SITE PLAN APPLICATION

SITE PLAN REVIEW

Name of Proposed Development 7-11

RE: 7-Eleven at Kaufman & Goliad

SITE PLAN

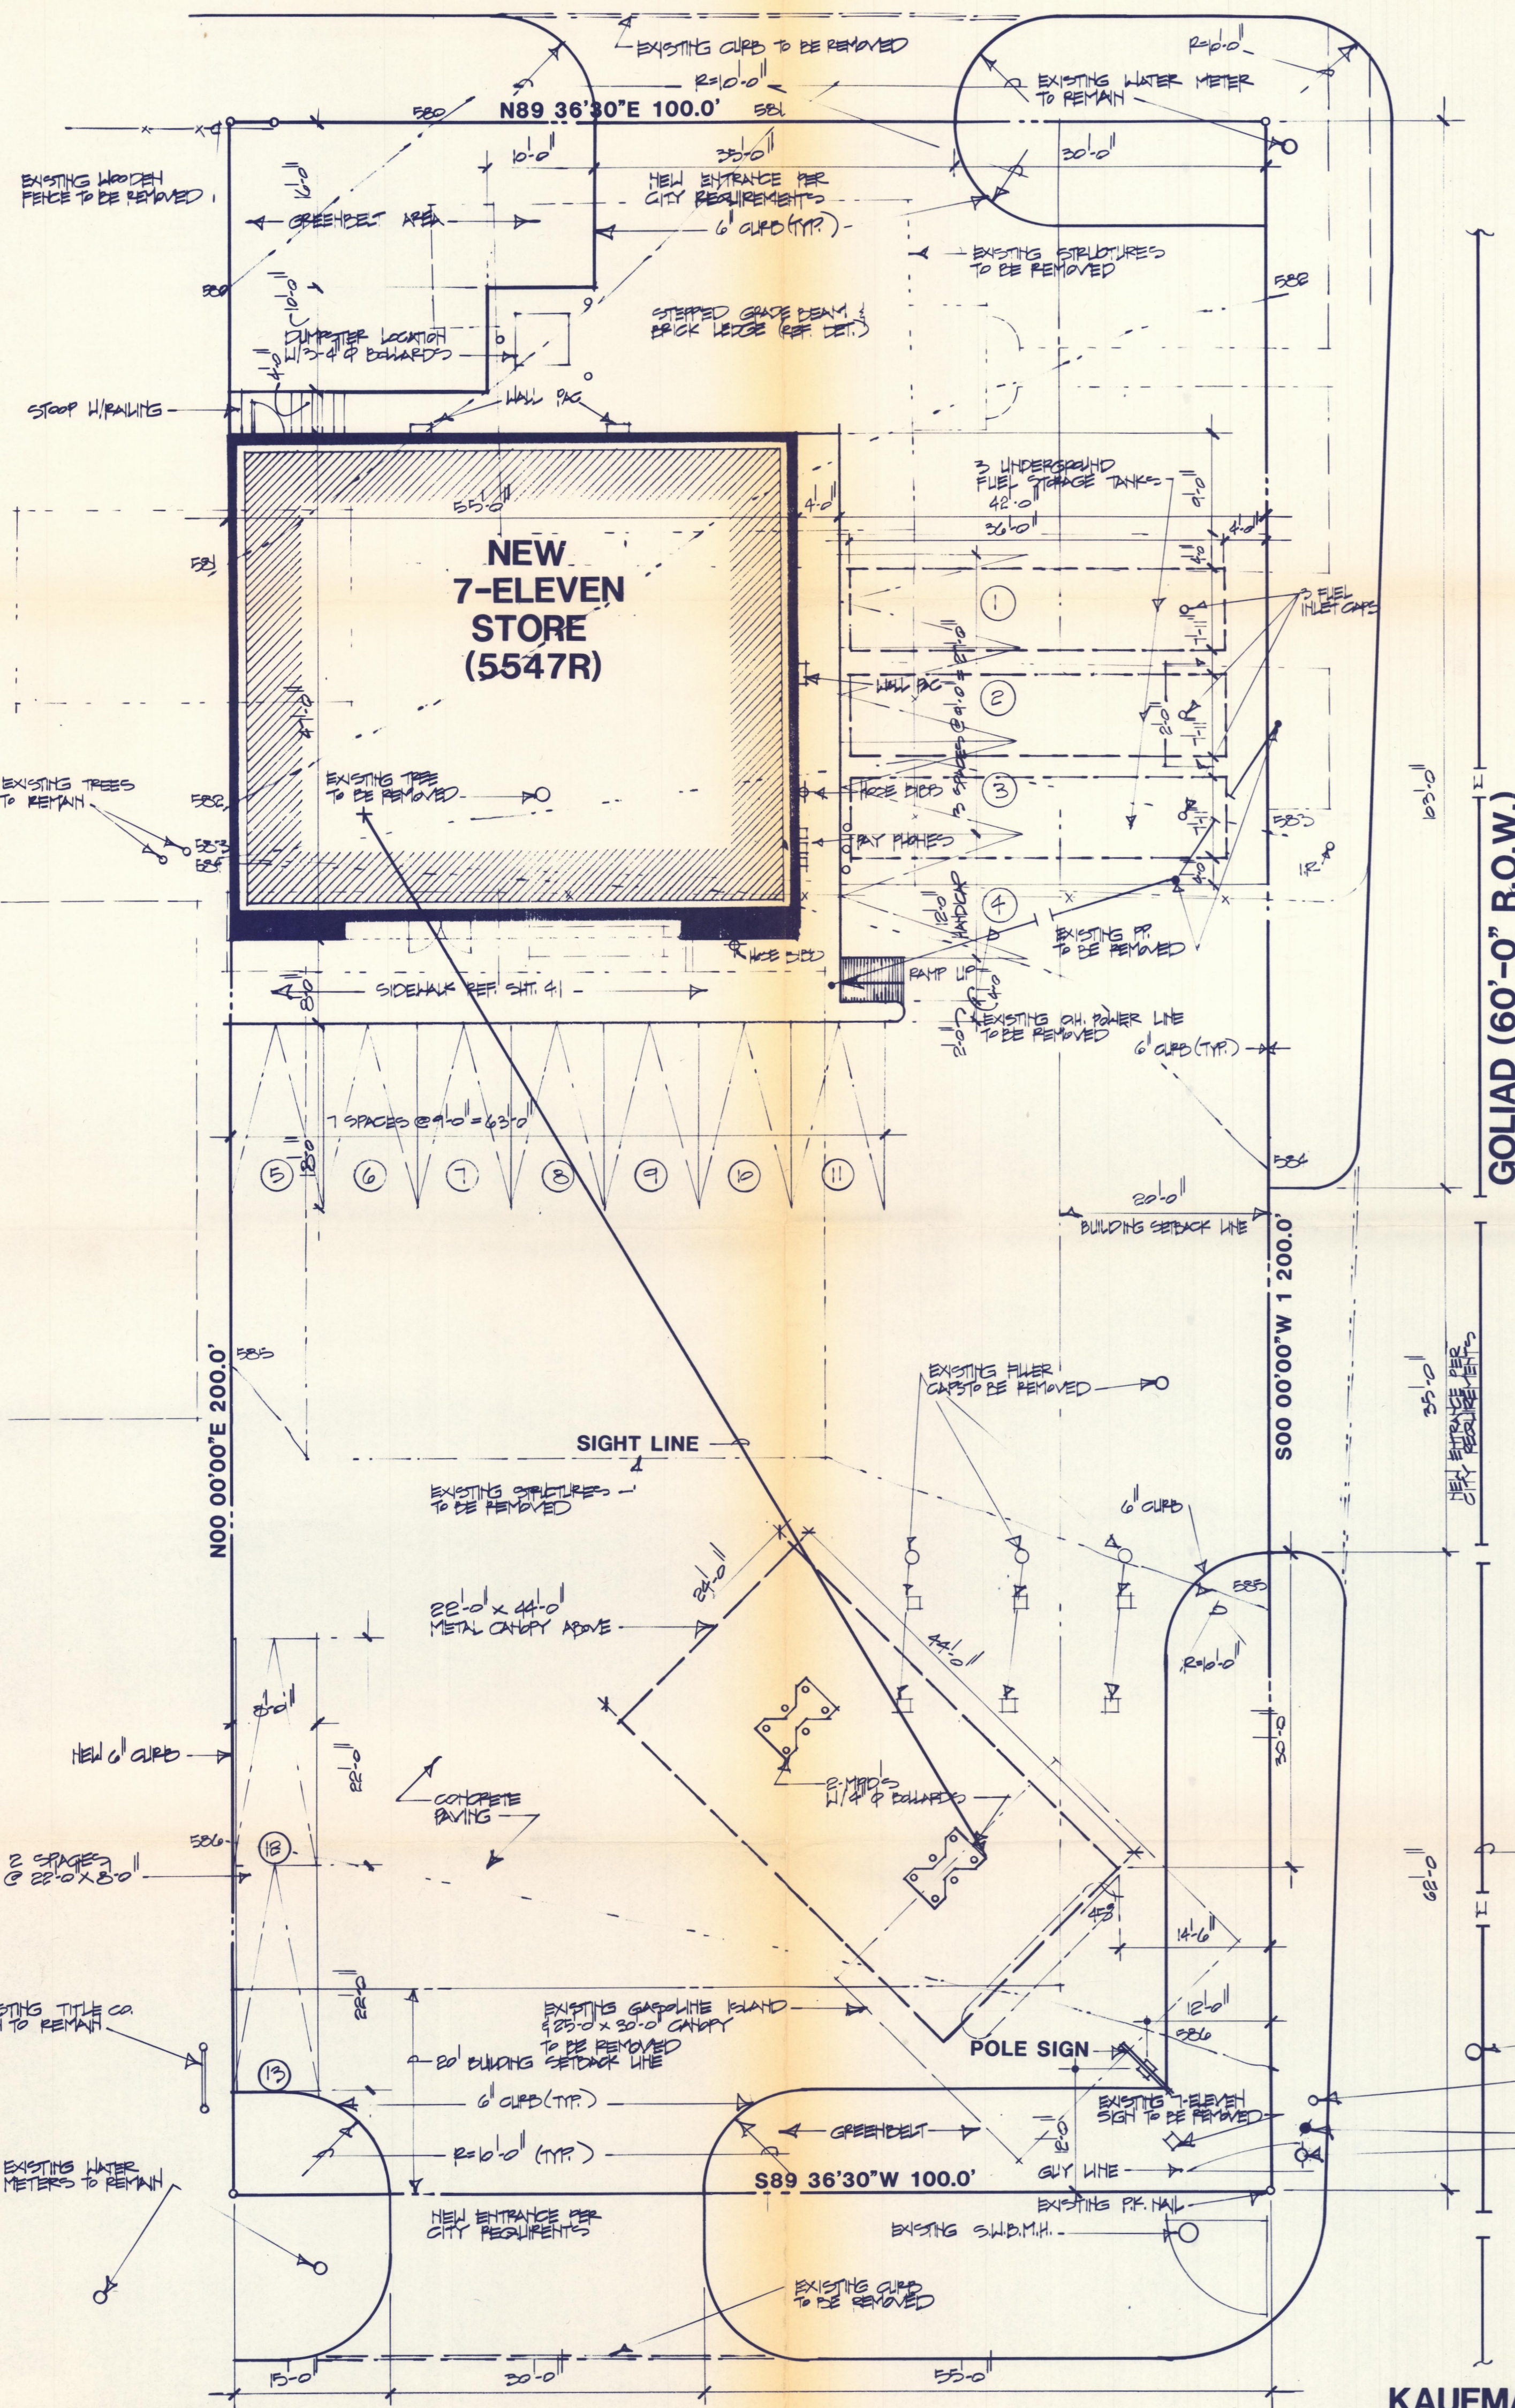
b. Building line <i>need to move rear Bldg. 80' further back.</i>	<input type="checkbox"/>	<input checked="" type="checkbox"/>	<input type="checkbox"/>

c. Buffering	<input type="checkbox"/>	<input type="checkbox"/>	<input checked="" type="checkbox"/>
d. Landscaping <i>need to define better</i>	<input type="checkbox"/>	<input type="checkbox"/>	<input type="checkbox"/>

e. Parking <i>need to verify sq footage in Bldg</i>	<input type="checkbox"/>	<input type="checkbox"/>	<input type="checkbox"/>
f. Lighting	<input type="checkbox"/>	<input type="checkbox"/>	<input checked="" type="checkbox"/>

1. Does plan conform to Thoroughfare Plan? <i>need to move Bldg back from Interarkam</i>	<input type="checkbox"/>	<input checked="" type="checkbox"/>	<input type="checkbox"/>
2. Do points of access align with adjacent ROW?	<input type="checkbox"/>	<input type="checkbox"/>	<input checked="" type="checkbox"/>
3. Are the points of access properly spaced?	<input checked="" type="checkbox"/>	<input type="checkbox"/>	<input type="checkbox"/>
4. Does plan conform with Flood Plain Regulations?	<input type="checkbox"/>	<input type="checkbox"/>	<input checked="" type="checkbox"/>
5. Will escrowing of funds or construction of substandard roads be required?	<input type="checkbox"/>	<input checked="" type="checkbox"/>	<input type="checkbox"/>

SITE PLAN

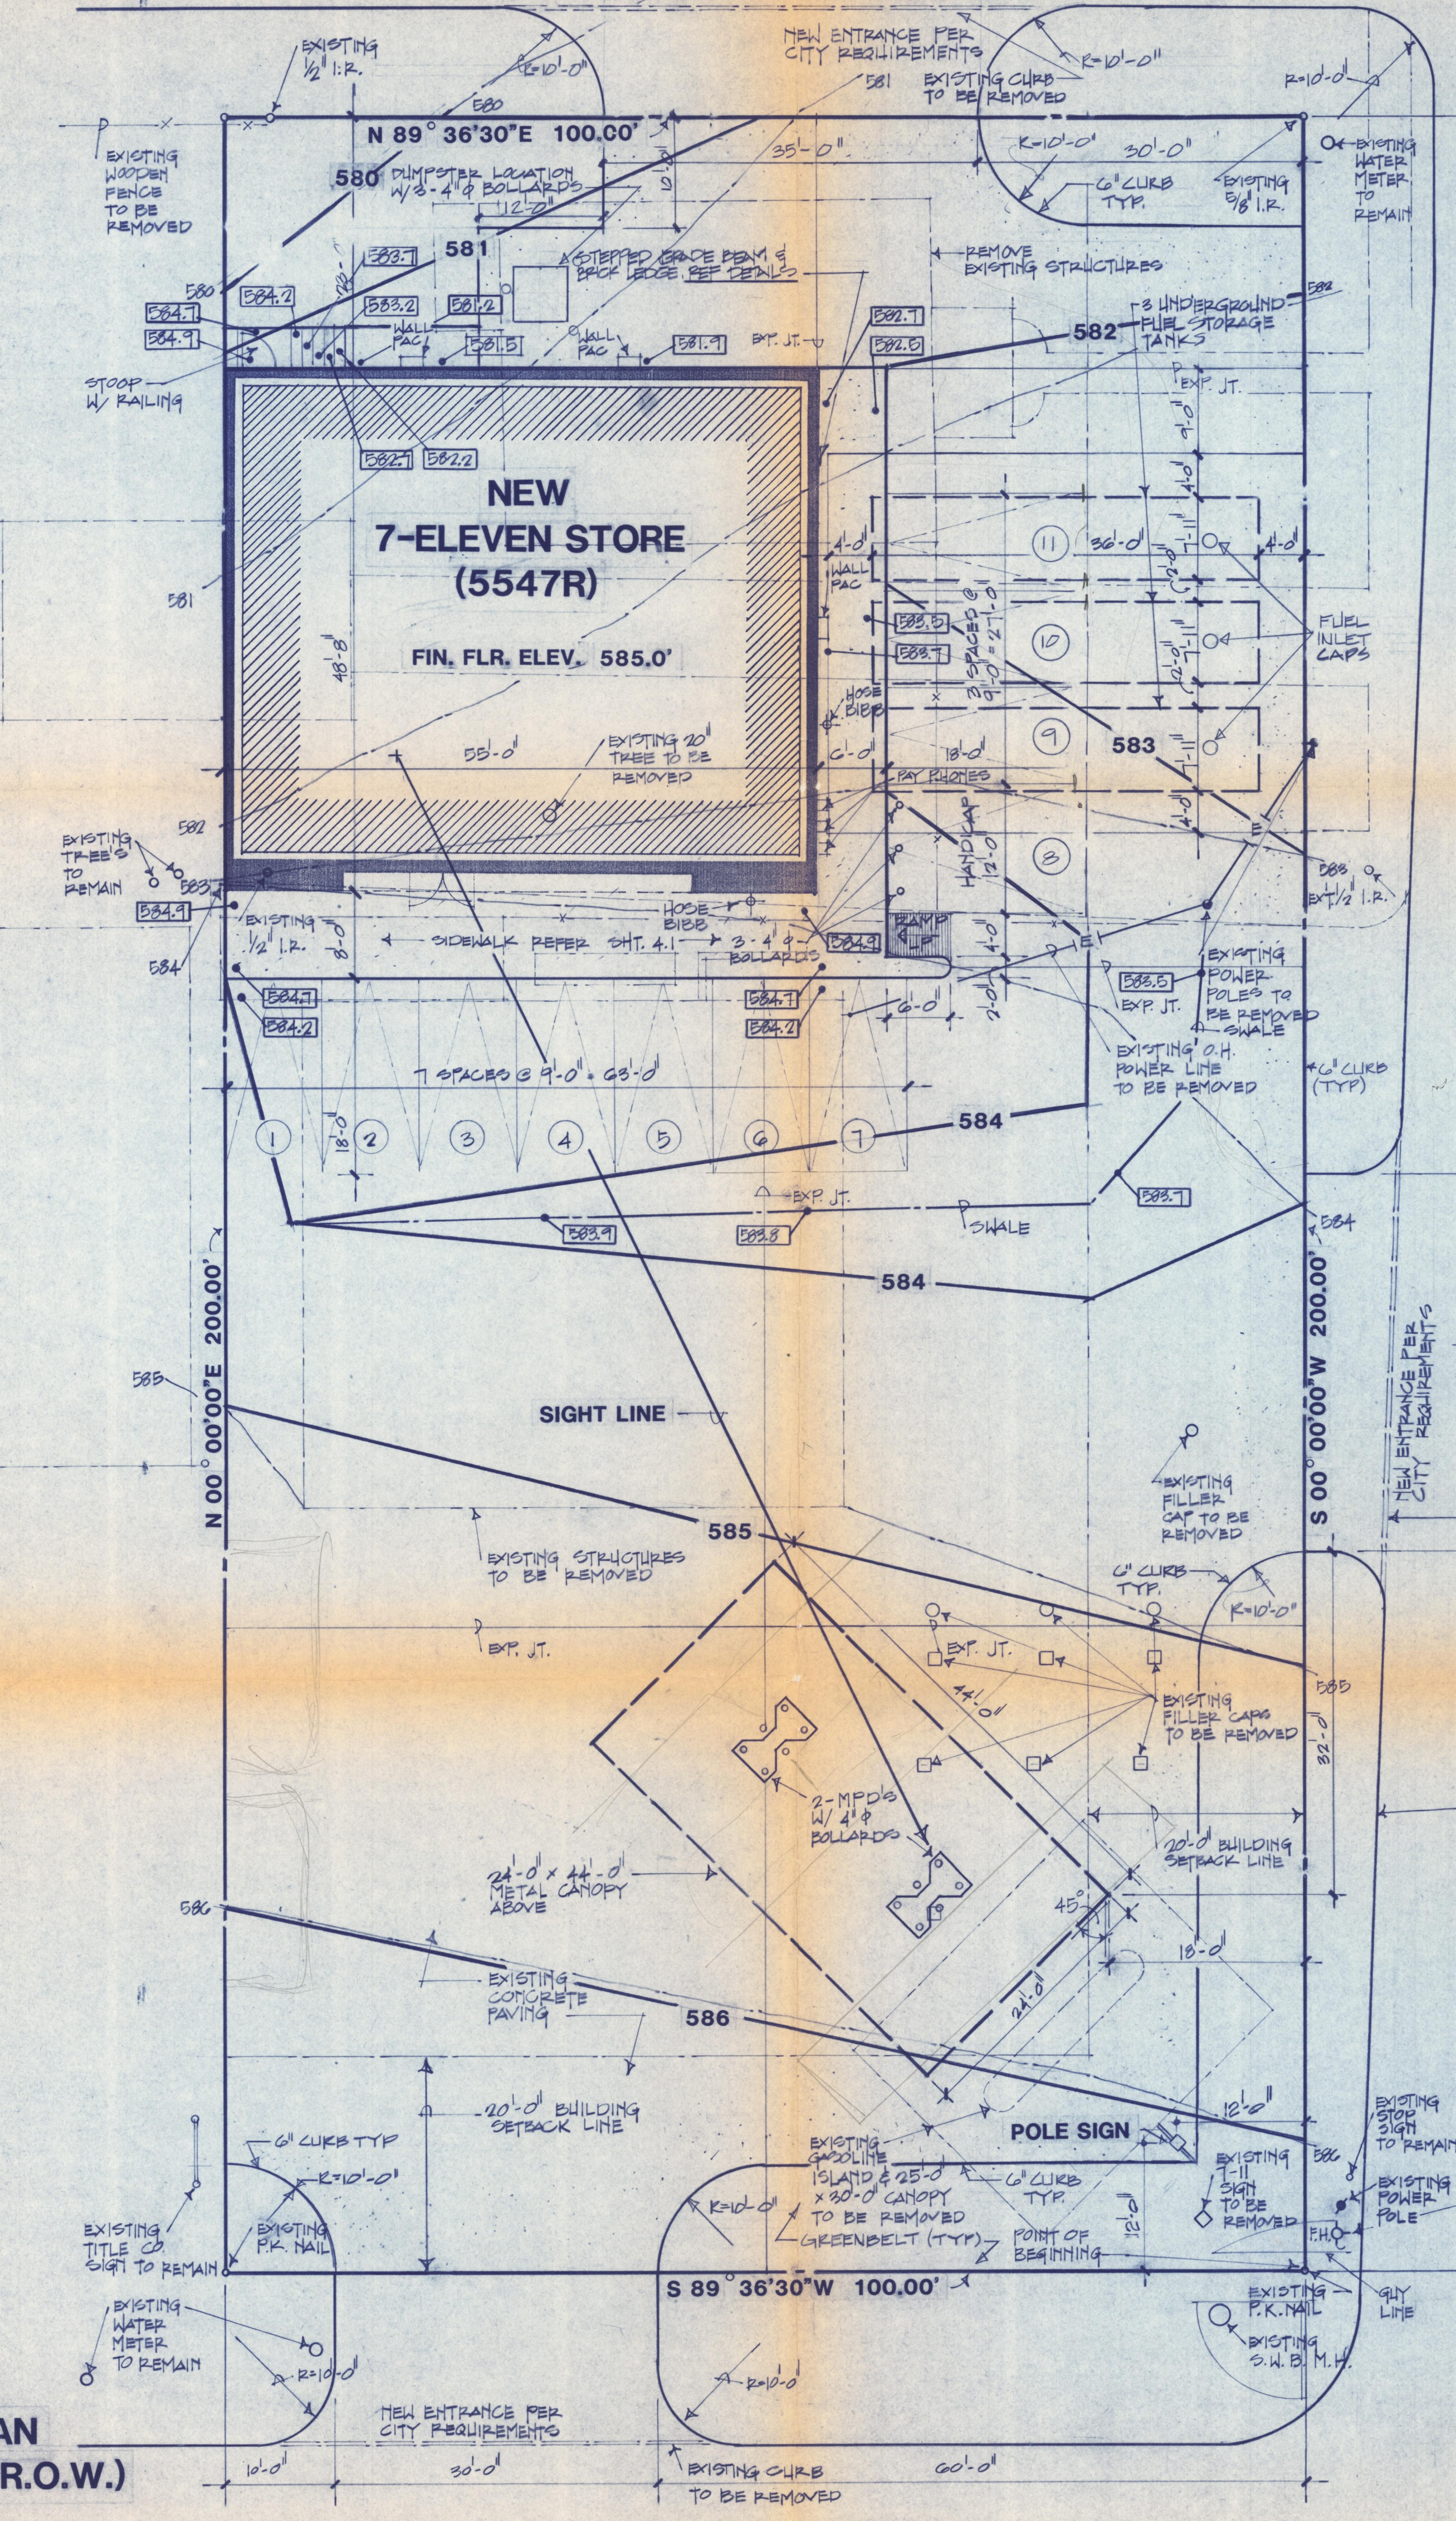
- Remove most northerly entrance on Goliad
- Provide 10% landscaping
- Provide 6" curb at all greenbelts & property lines
- Move entrance on Interurban 10' west to provide 30' clearance from corner.
